City of Lone Tree Planning Commission Agenda Tuesday, May 24, 2016

TO: City of Lone Tree Planning Commission

Approval of a Site Improvement Plan (SIP) to construct a single-story, 9,930 square-foot, medical office building on 1.05 acres in RidgeGate. In conjunction with this SIP, there are two variances proposed: one is a variance to the City parking standards to allow parking in excess of the City's maximum standards; the other is a variance to the RidgeGate Office District Sub-Area Plan regarding waiver of a build-to standard that would allow the building to be set back 10 feet from the street.

RIDGEGATE SECTION 15 FILING NO 12, FIRST AMENDMENT, LOT 3B

1 ELEVATION EAST
 3/16" = 1'-0"

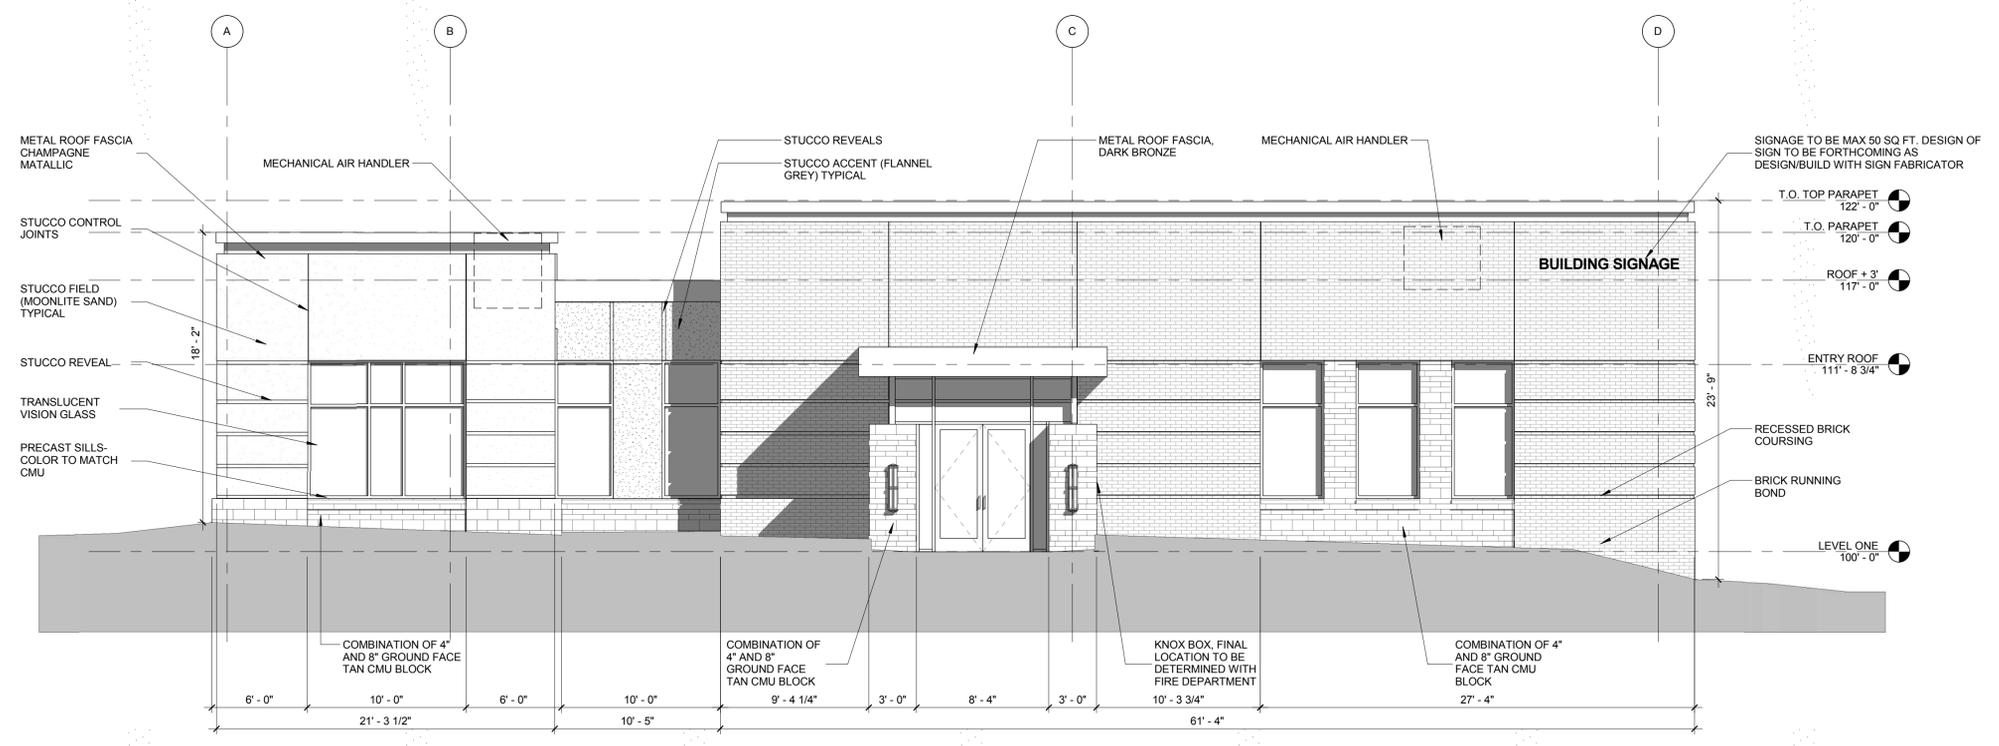
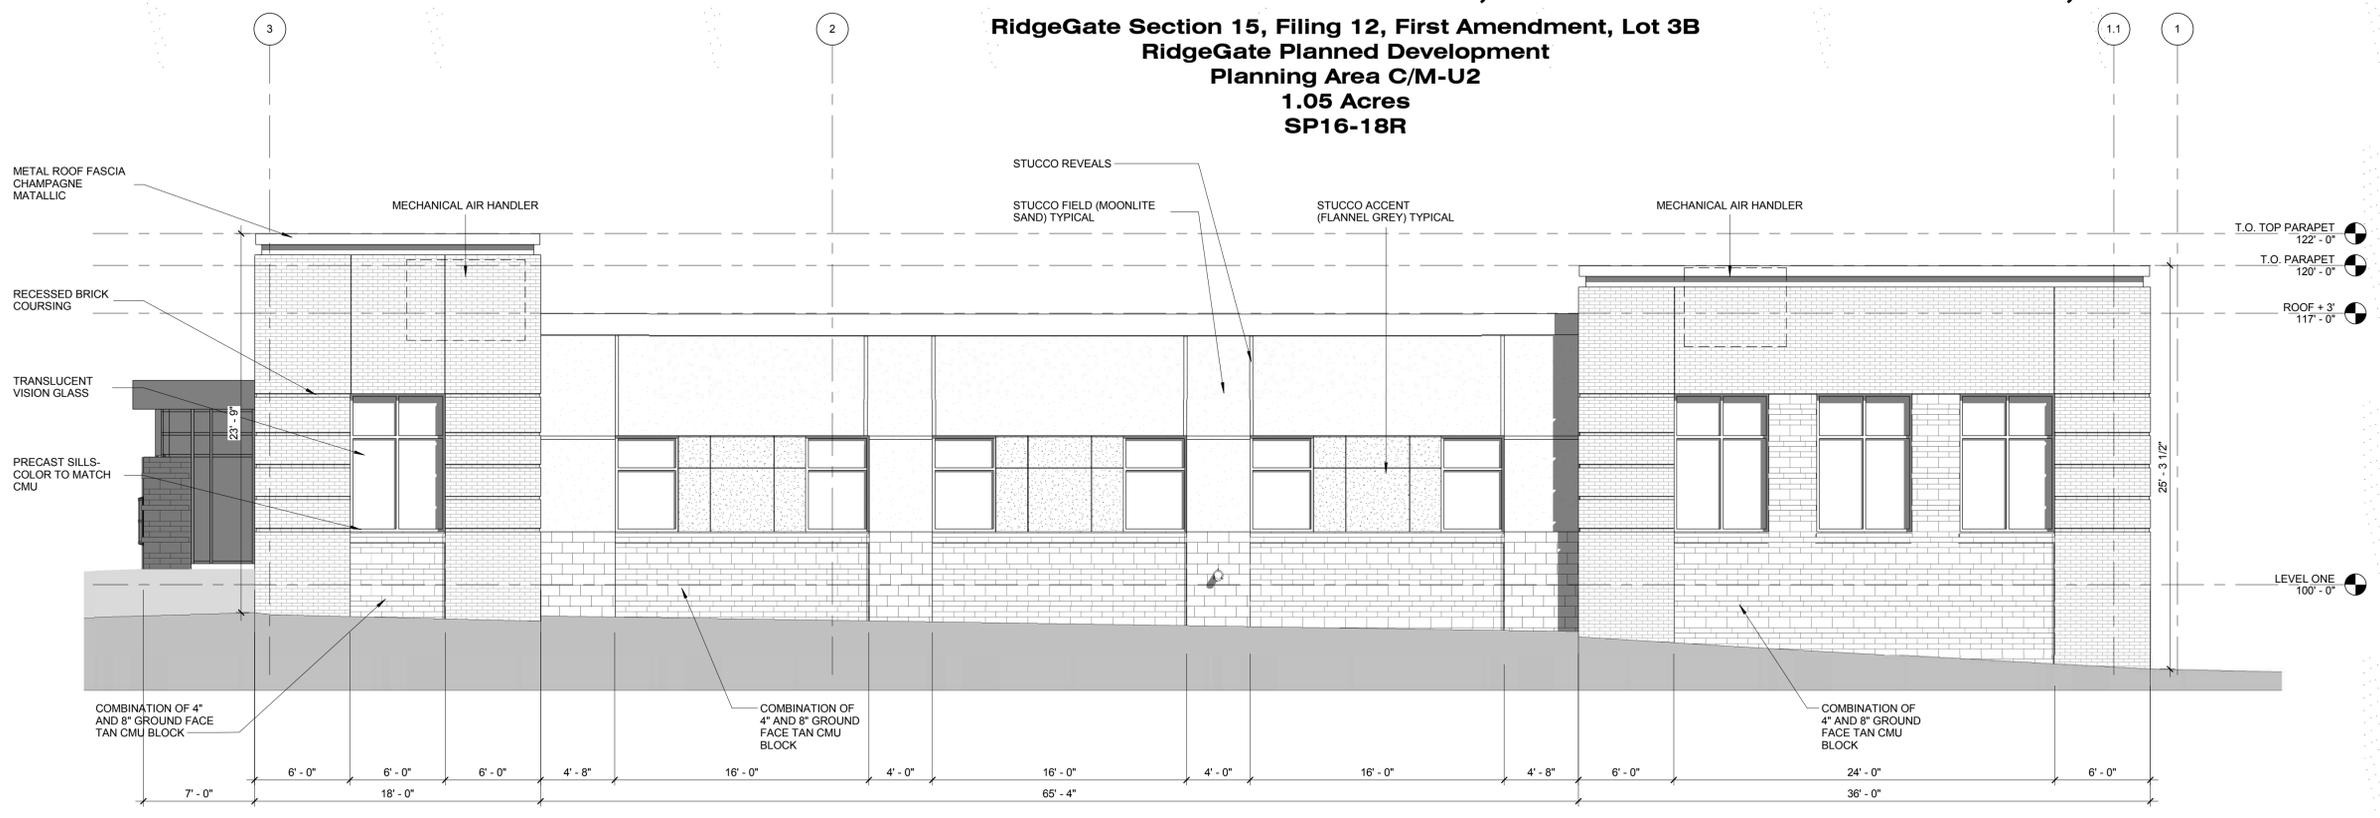
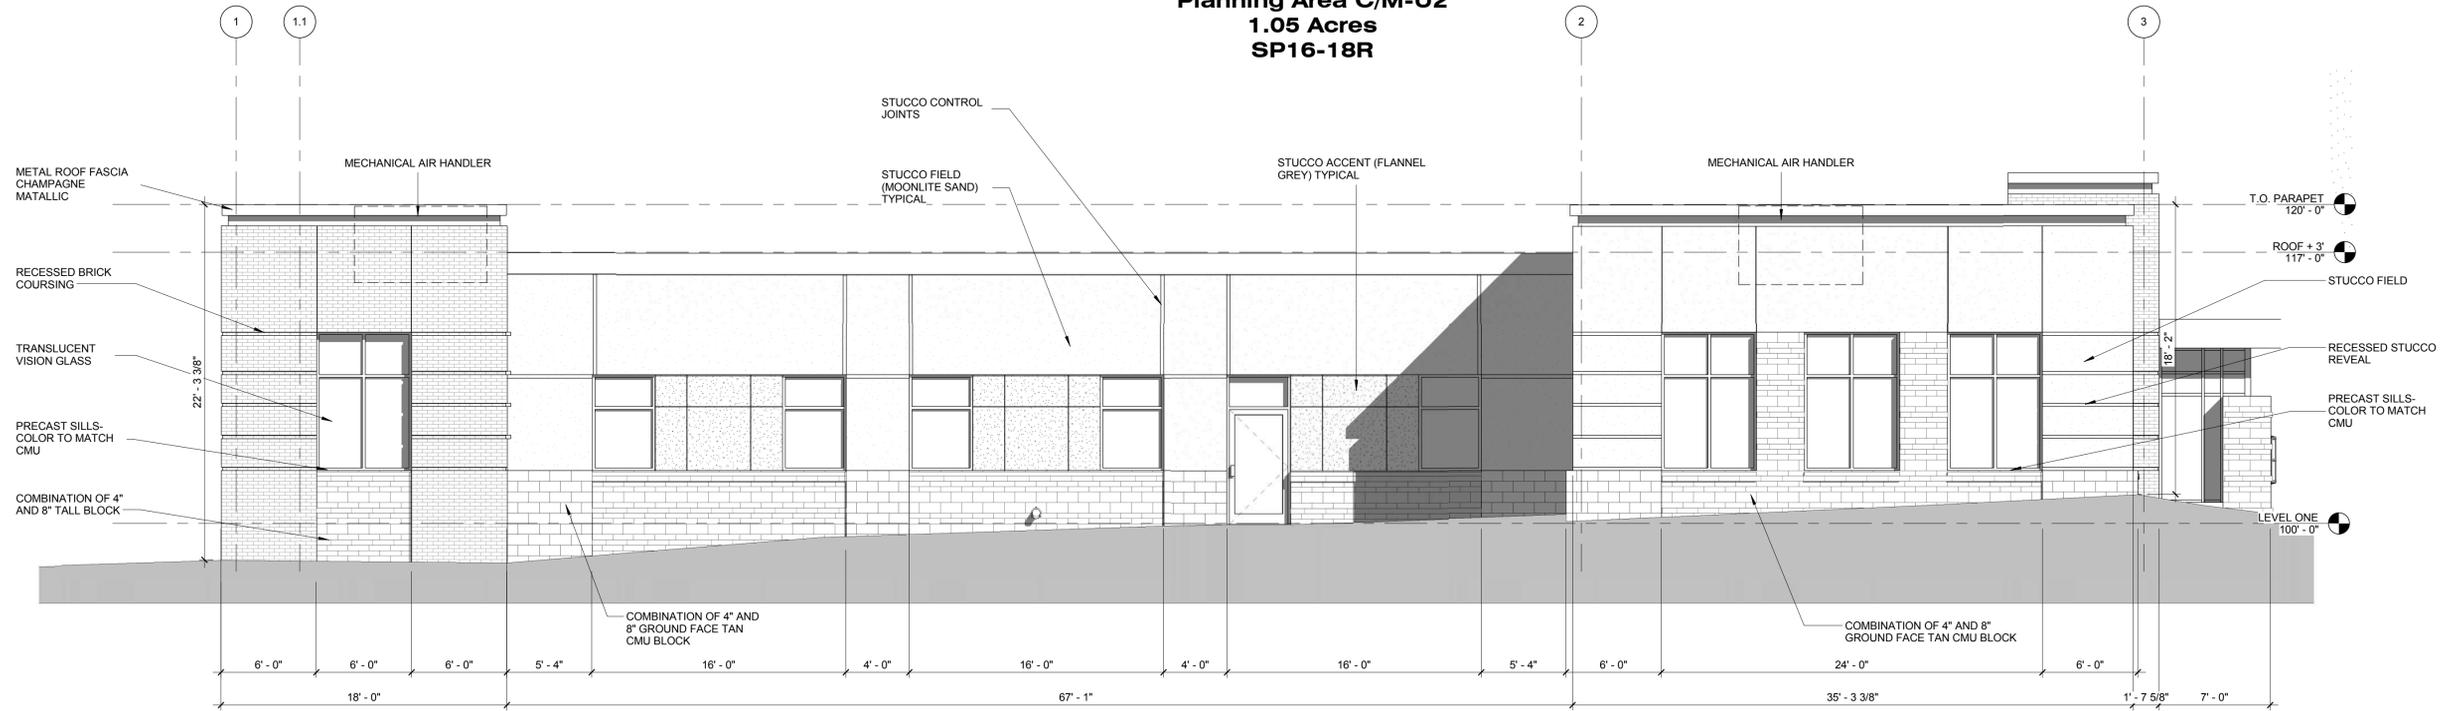
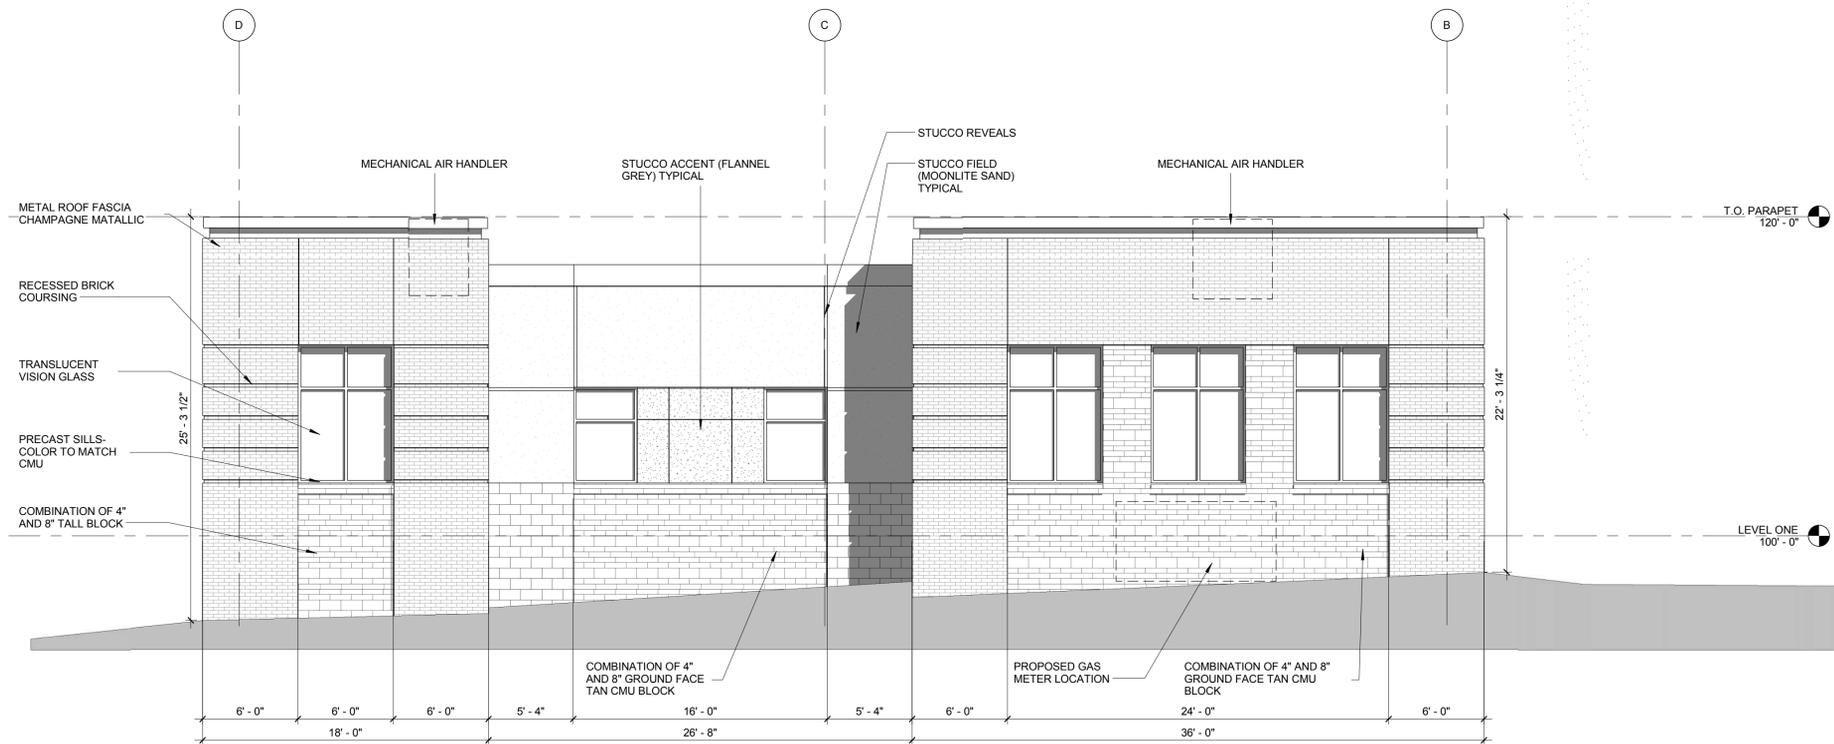
- Use another type of brick in place of the cultured stone.
- Enhance the south side elevation.
- Add depth to the reveals, i.e. add an eyebrow sunshade or another layer of detail.

- Add depth to the entry to emphasize.
- Consider using a different building mounted lighting unit on the south elevation.
- Consider offsetting the wall connections at corners to add depth.

- Corner parapet stucco detail, consider using champagne break metal detail rather than stucco. See the Douglas County Library building for an example of metal material.
- Consider tinted grout/mortar color (tan) for brick.
- Provide a sample of the base CMU block or a photo example and specs.

- Add seating wall cap detail to the plans.
- Adjust graphics to accurately depict the CMU color. Consider adding shade and shadows to better depict reveals and wall setbacks.

- The CMU base was modified and now includes 3 inch and 4 inch courses to add patterning and interest.
- Stucco material will be painted tan and gray.
- Window sills will be precast.
